604123-111717

ADDENDUM NO. 5

**Federal Aid Project Nos. CMQ-003S(390), STP-003S(390) & TAP-003S(390)
Roadway Reconstruction and Related Work along Route 126 (Pond Street)**

Transmitting revisions to the Contract Documents as follows:

ELIOT STREET RETAINING WALL
PLAN AND ELEVATION
SHEET 2 OF 2

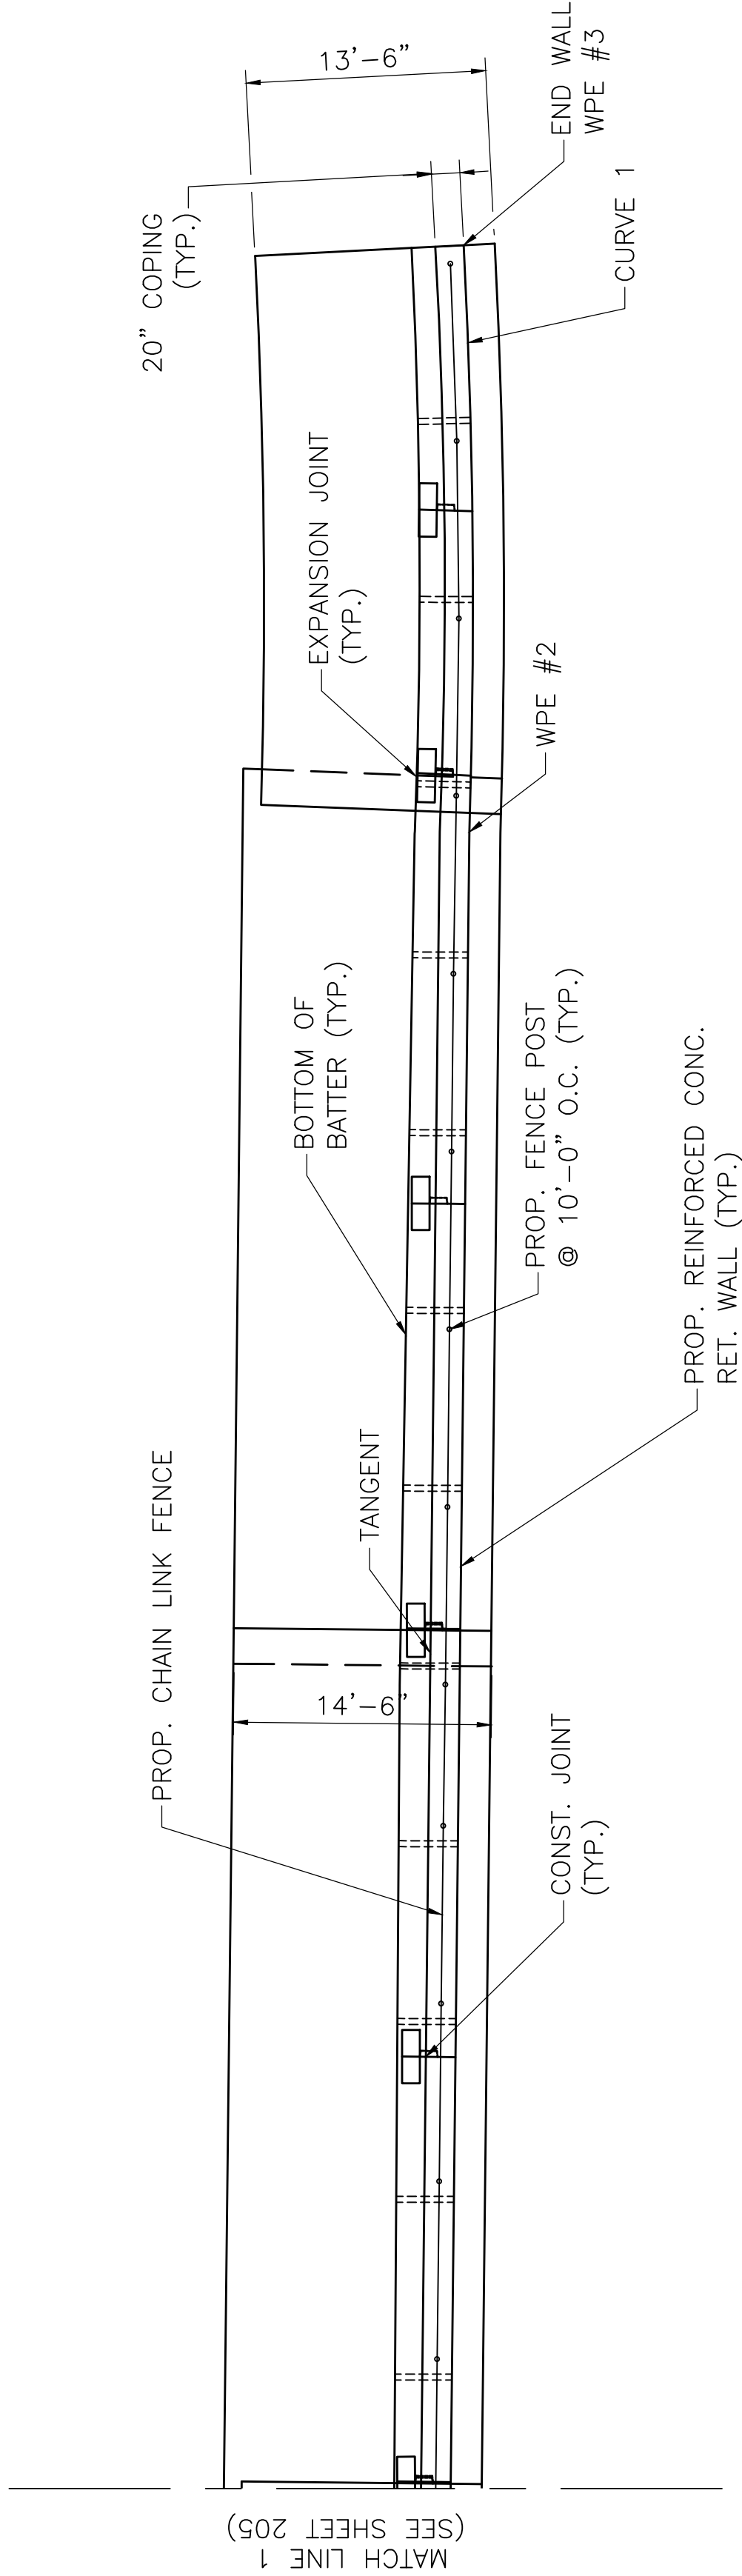
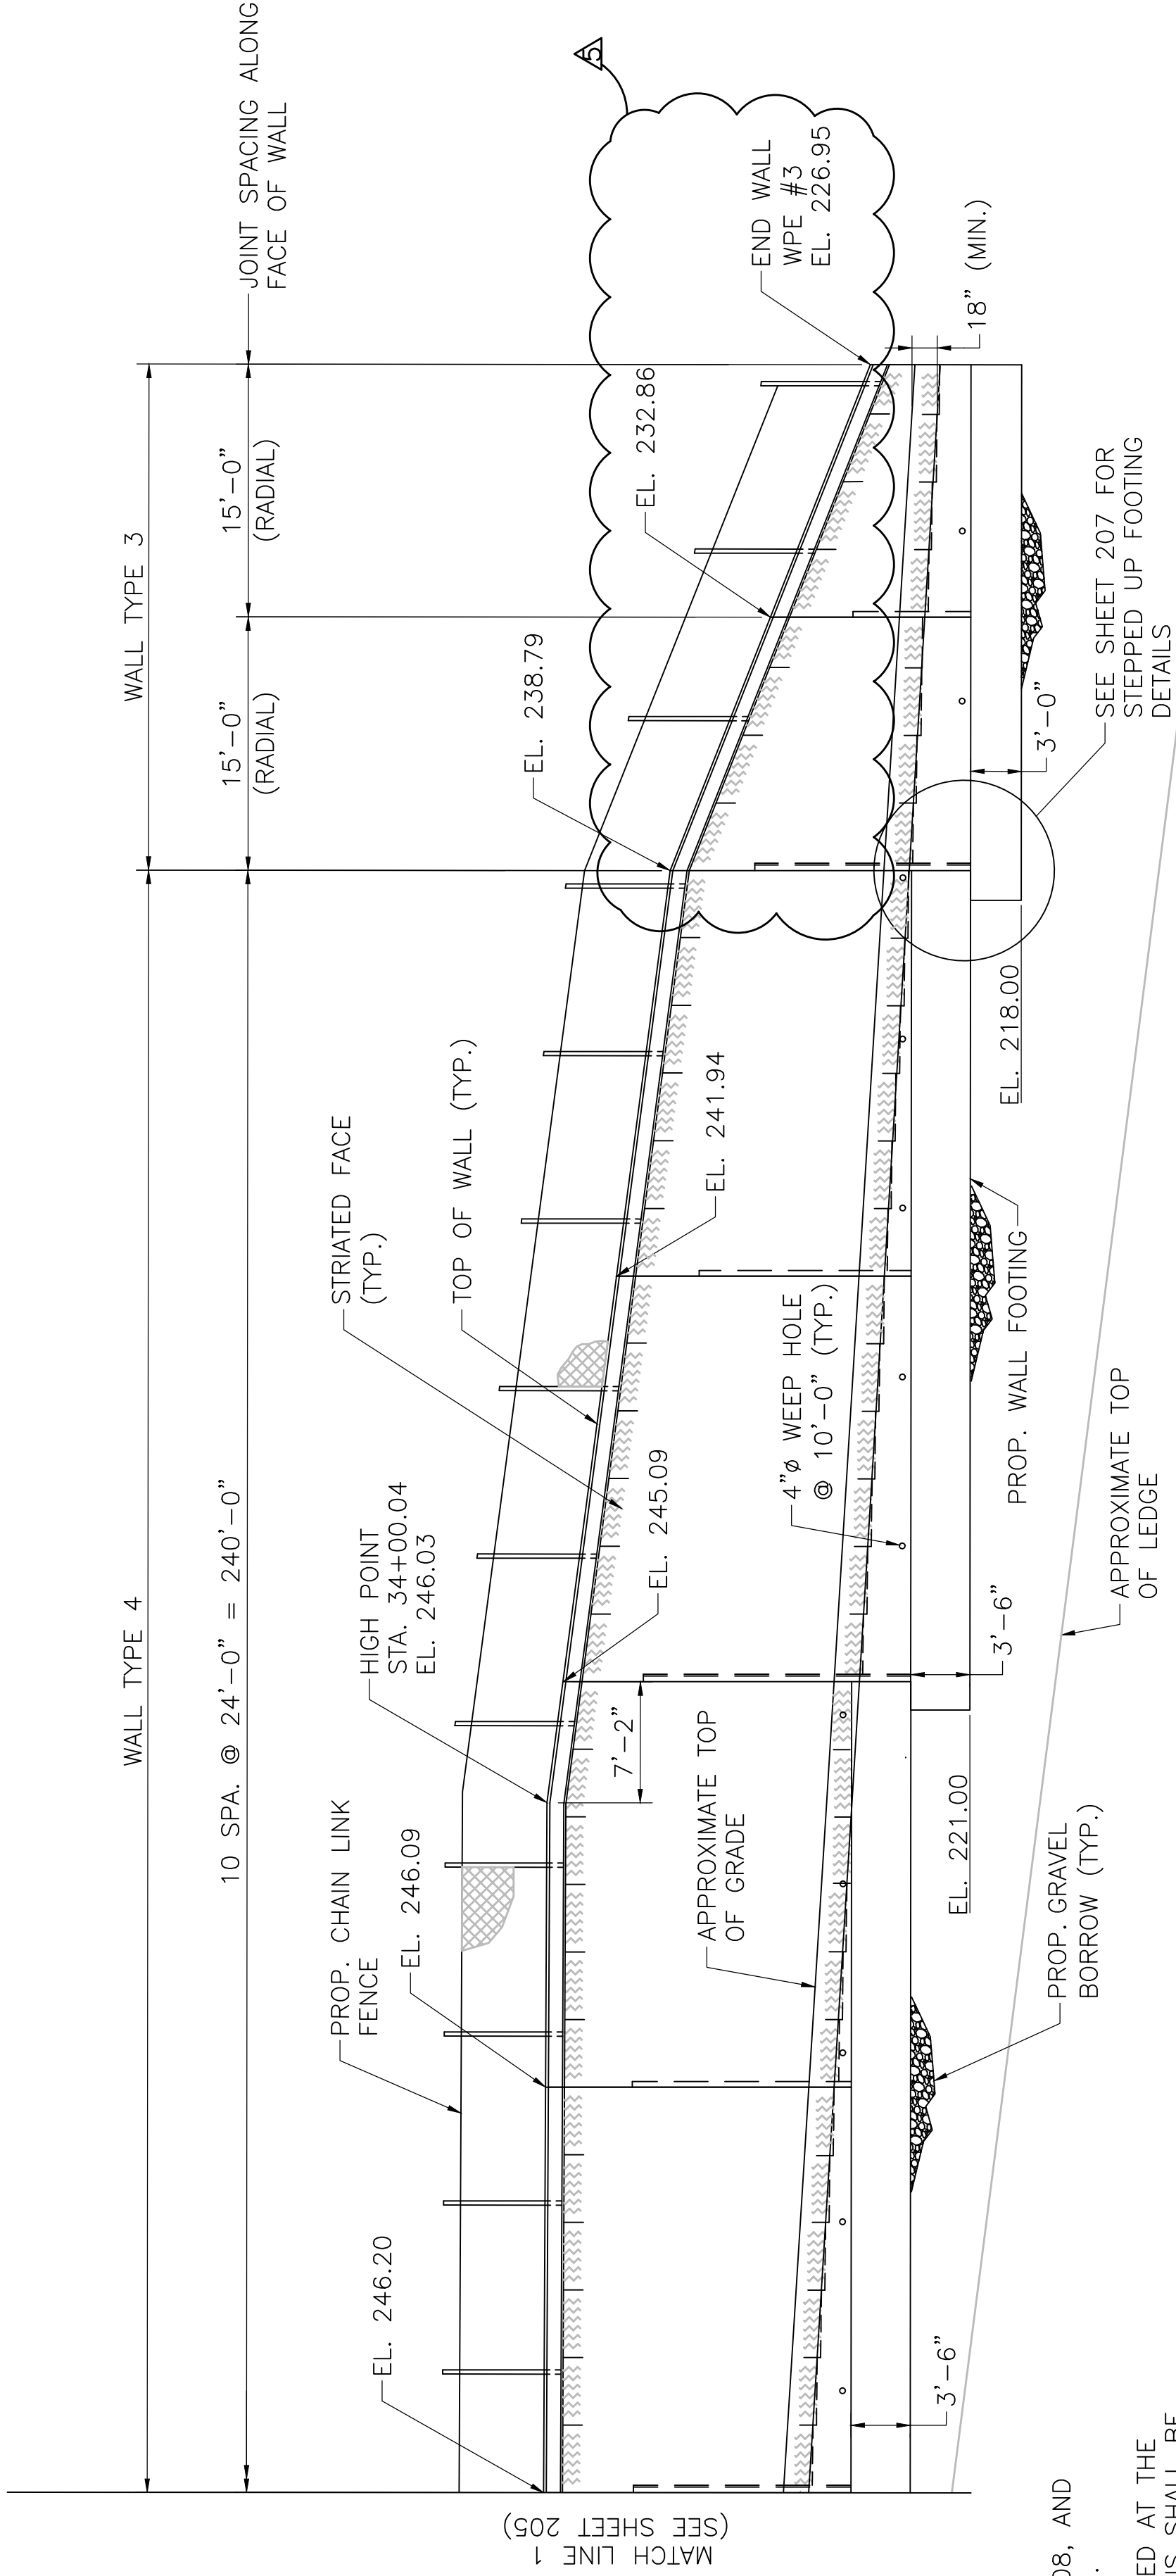
Question #28: At the start and end of Eliot St. retaining wall, the exposed heights are +/-7' +/-10' respectively. Can the wall ends be extended or grading plans be provided for the Eliot St. wall ends as this seems extremely high to have the retaining walls end at those heights.

Question #41: The plans for the Eliot Street retaining wall include footing elevations that differ from the elevations shown in the cross section. At station 32+50, the cross section shows the bottom of the footing for the wall slightly below 232'. The Plans show the footing to be placed at 234'. Please clarify which drawing will govern.

Response #28: See revised Sheets 205 and 206 of 331.

Response #41: The plans for the Eliot Street retaining wall will govern the bottom of footing elevation. See revised Sheets 205 and 206 of 331.
